Chaity Composite Ltd.- Annex building

Chotto Shilmondi, Tripurdi, Sonargaon

15th March 2021

Building Information

Column Layout plan

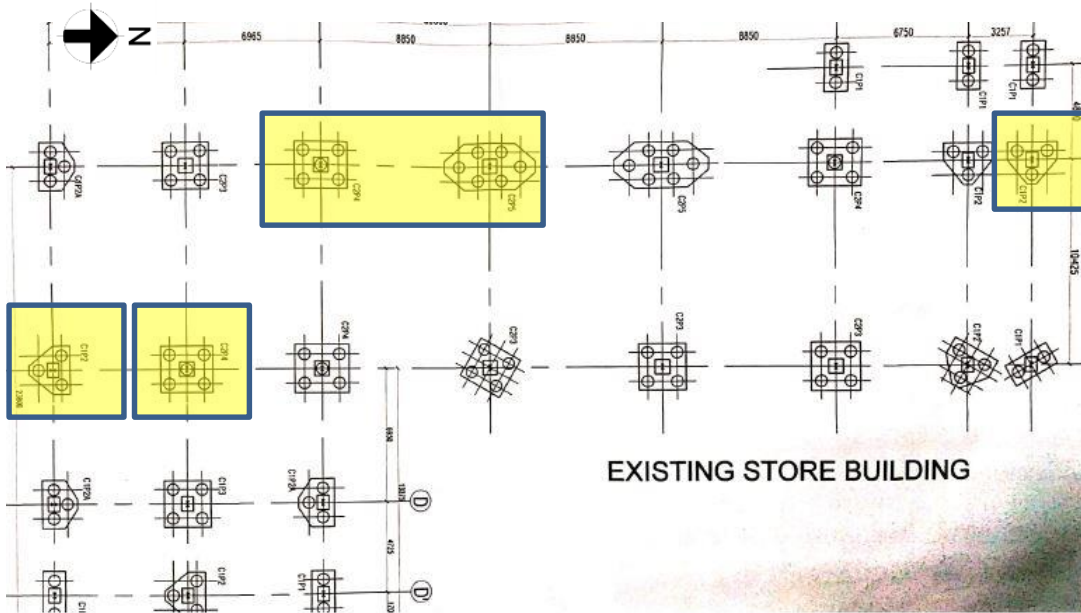
Cursory calculation indicates that columns are stressed above normal design limits at the marked locations considering 5 kPa live load on typical floor. Factory Engineer to review design, loads and columns stresses. Also produce and actively manage loading plan according to the floor capacity.

Column Layout plan

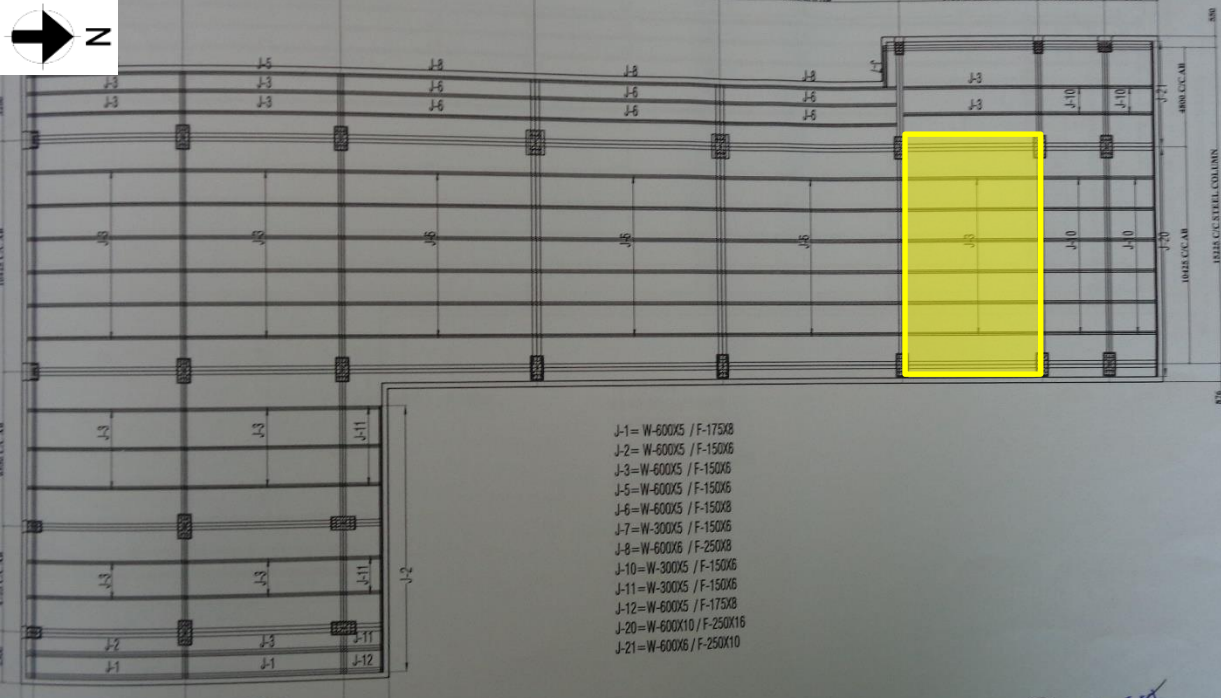
Cursory calculation indicates that foundation is stressed above normal design limits at the marked locations considering 5 kPa live load on typical floor. Factory Engineer to review design, loads and columns stresses. Also produce and actively manage loading plan according to the floor capacity.

Typical sub-beam layout

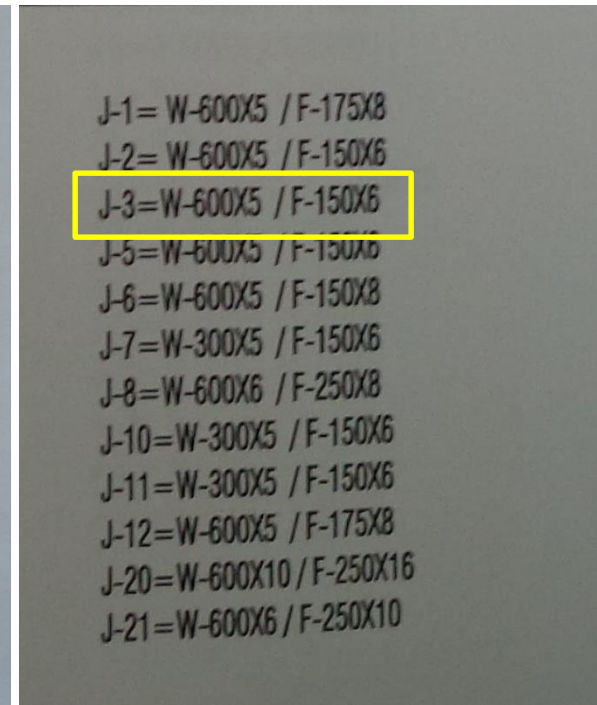
Depth of J-3 shown 600 mm

Depth of sub-beam (J-3) was shown as 600 mm in provided drawing for the marked area but the depth was measured as 500mm for those beams at all floor level. Factory engineer is required to survey the whole structure and update the as-built drawing as per on-site condition.

Depth of J-3 measured 500 mm
